Well Name: JICARILLA BR B	Well Location: T25N / R4W / SEC 34 / SESE / 36.3518865 / -107.2336273	County or Parish/State: RIO ARRIBA / NM
Well Number: 13	Type of Well: CONVENTIONAL GAS WELL	Allottee or Tribe Name: JICARILLA APACHE
Lease Number: JIC66	Unit or CA Name:	Unit or CA Number:
US Well Number: 3003905697	Operator: HILCORP ENERGY COMPANY

Subsequent Report

JICARILLA BR B 13**30.039.05697****PLUG AND ABANDONMENT**

Subject: [EXTERNAL] P&A Revision Request for Hilcorp's JICARILLA BR B 13 (API # 3003905697)

Current Schematic - Version 3

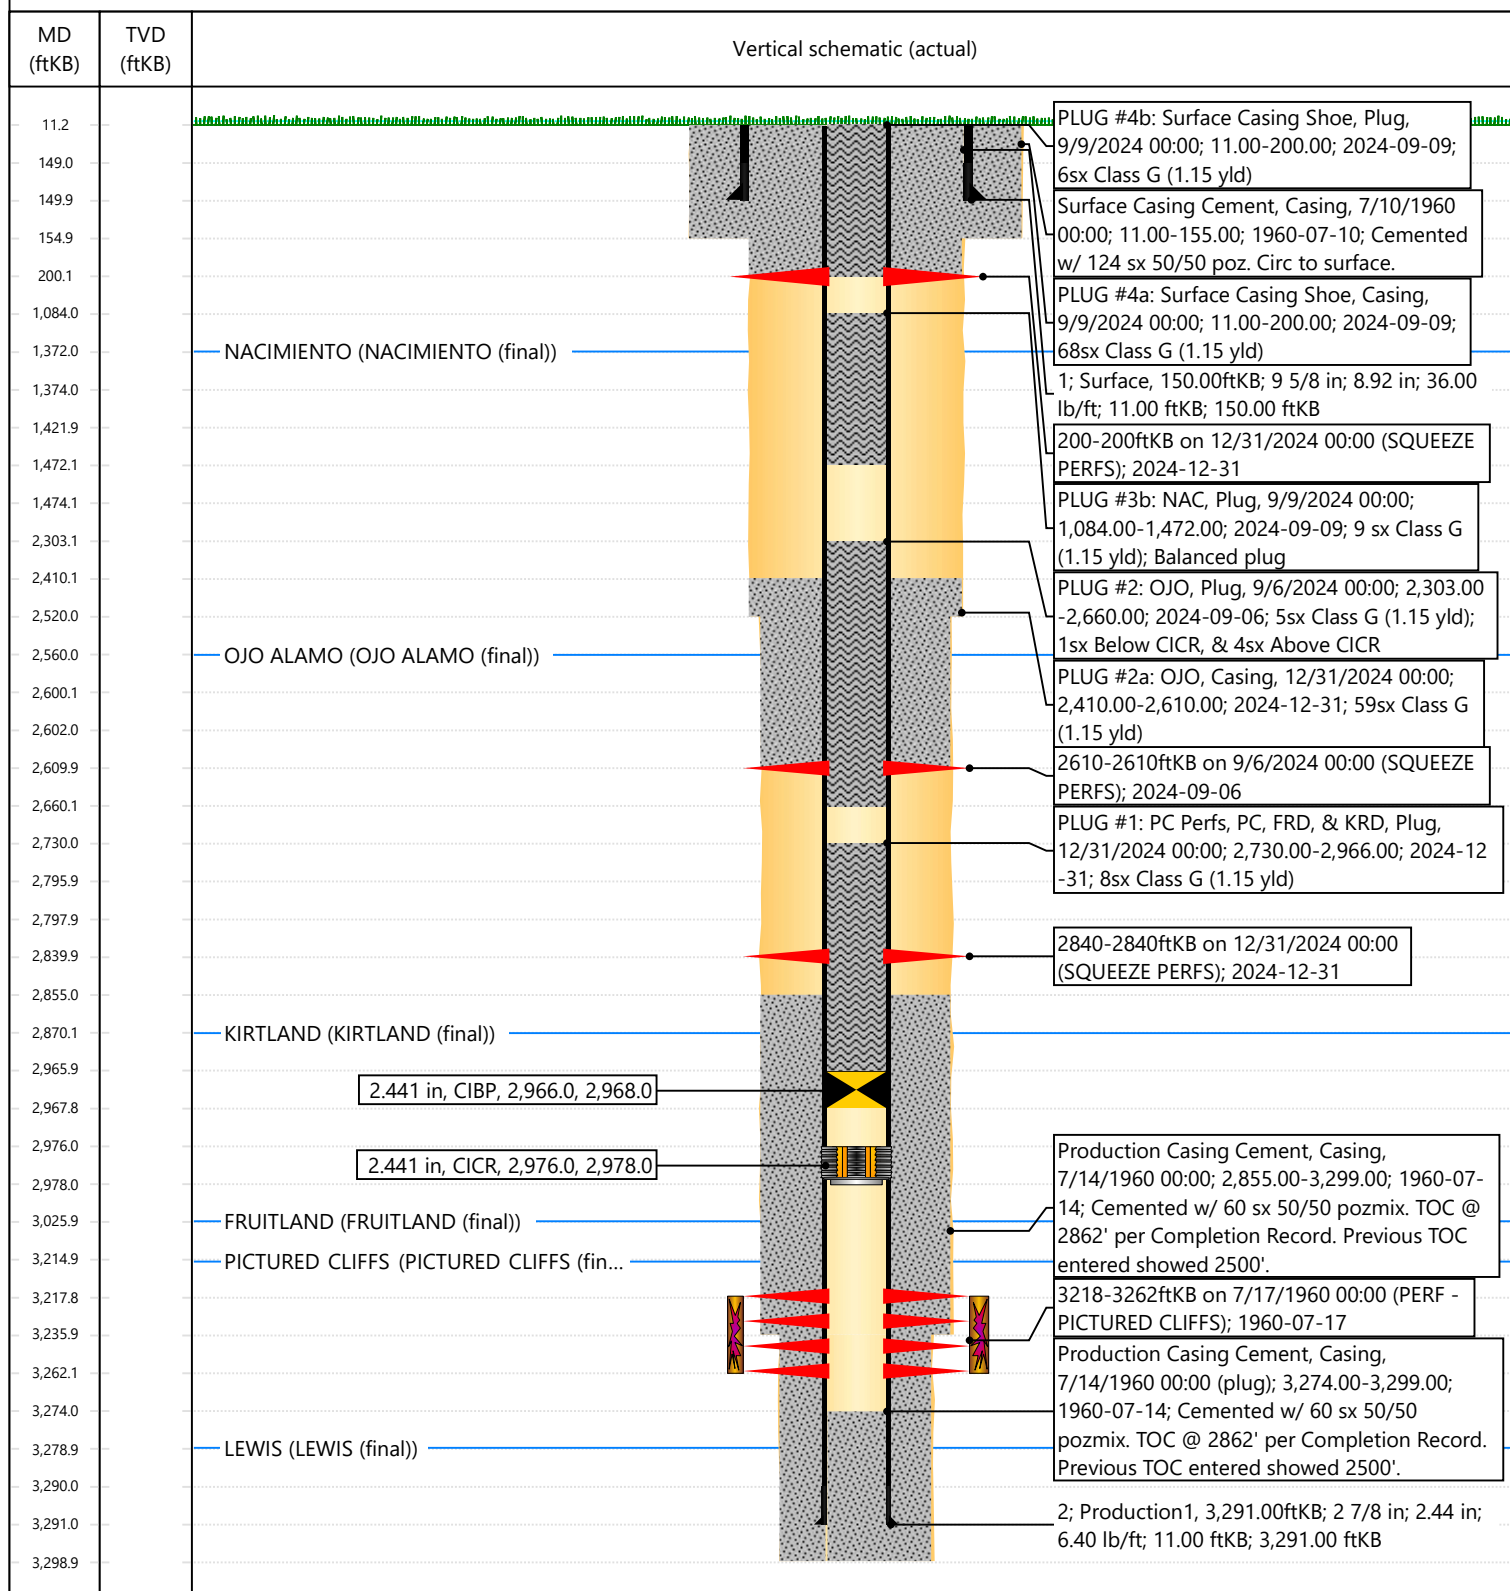
Per our discussion, Hilcorp attempted to RIH w/ a 2-7/8" CIBP and tagged high at 1,674'. We then TIH w/ work string & bit & hard tagged @ 3,226'. We reamed on the way out of the hole. We then TIH w/ the same CIBP & tagged @ 3,000' and could not get deeper.

- Set a **2-7/8" CICR @ 2,976'**
- **Pump PLUG #1: 9sx of Class G Cement (15.8 PPG, 1.15 yield); PC Perfs @ 3,218' | PC Top @ 3,215' | FRD Top @ 3,026':**

- Pump 9sx of cement beneath the 2-7/8" CICR (est. **TOC @ +/- 2,976'** & est. **BOC @ +/- 3,265'**). Wait on Cement for 4 hours, tag TOC w/ work string. *Note cement plug lengths & volumes account for excess.

- Verbal approval was given from BLM that if Hilcorp is unable to establish an injection rate below the CICR @ 2,976', Hilcorp can forego pumping cement below CICR @ 2,976'.

- Set a **2-7/8" CIBP @ 2,966'** (No cement will be pumped on top of CIBP @ 2,966' due to anticipated KRD perfs to be shot at ~2,920' for PLUG #2).
- The remainder of the procedure will be executed based on the updated formation tops stated in the COAs in the approved NOI. Those changes are reflected in the attached procedure.

- Please see the revised procedure attached and below. The updated Proposed P&A wellbore schematic is also attached.

The BLM finds the proposed procedure appropriate.
